1st Further Information

Proposed Temporary Shop and Services and Eating Place with Ancillary Facilities for a Period of 5 Years in "Village Type Development" Zone, Lot 390 RP (Part) in D.D. 106, Kam Sheung Road, Yuen Long, New Territories

(S.16 Planning Application No. A/YL-KTS/1036)

Responses-to-Comments

Figure 2 - Existing Drainage Plan

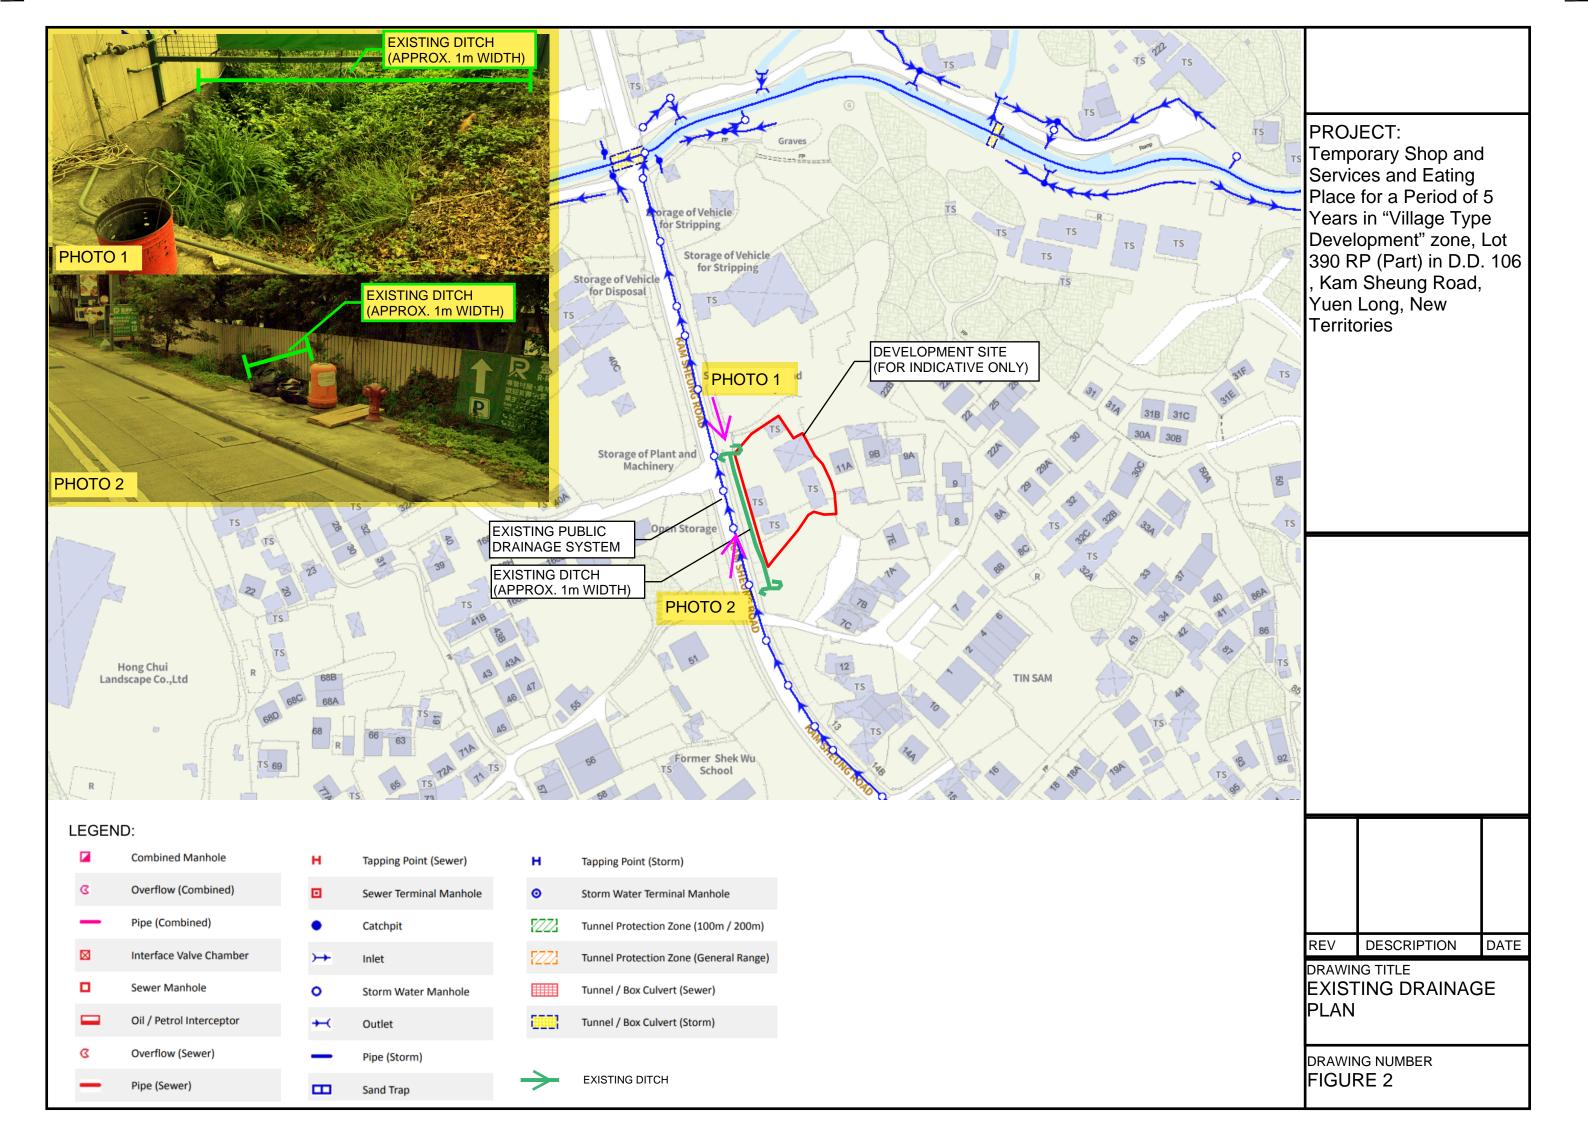
Departmental Comments	Applicant's Responses
1. (Comments of the Chief Engineer/Mainland No	rth, Drainage Services Department
	CE/MN, DSD)	
(a)	According to our record, there is no existing stream at the western side of the site. Please provide site photos to show existing condition of the existing drainage facilities which receives the discharge from the application site;	Noted. Please refer to the photo record of the existing drains in the western side of the site in updated Figure 2 of Annex I for your reference.

Figure 3 – Existing Internal Drainage System

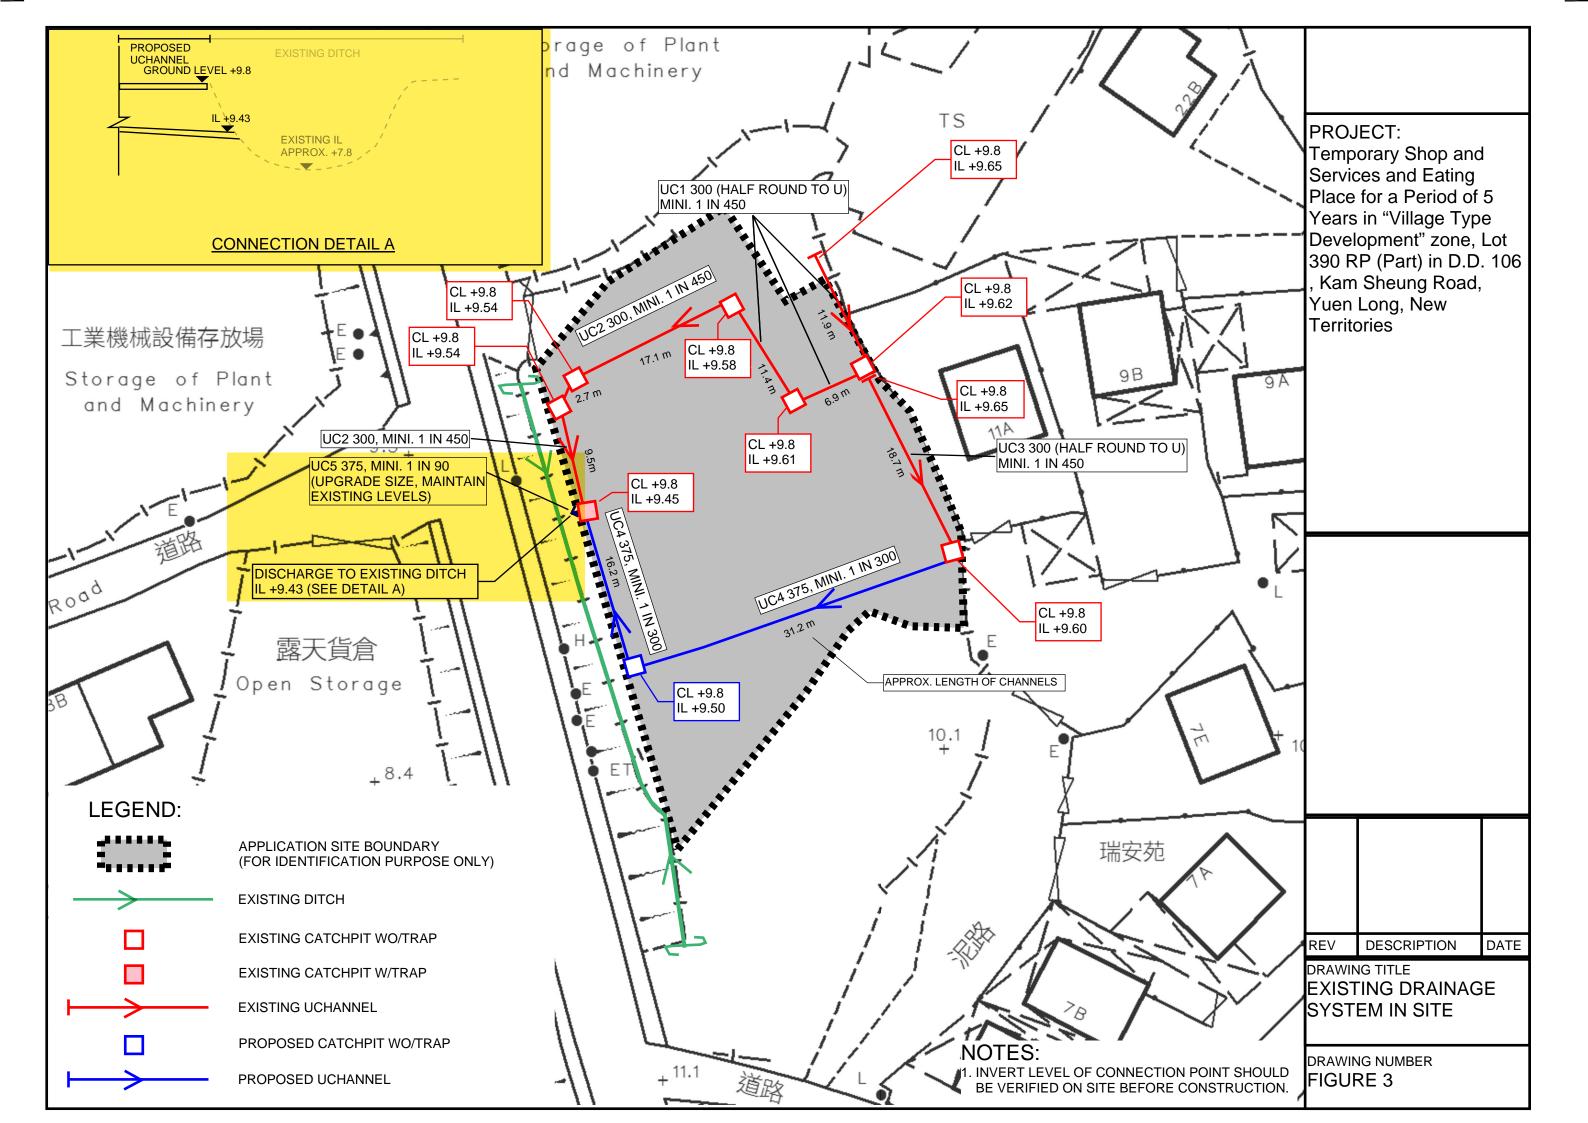
(d)	Please provide connection details of proposed U-channel at discharge point. Cross section showing all C.L. and I.L and bottom level details are required; and	Noted. Please refer to the updated Figure 3 of Annex I for your reference.

(e)	Please consider to adopt larger size of u- channel for UC5 to minimize the entry head.	Noted. Please also refer to the updated Figure 3 of Annex I for your reference.
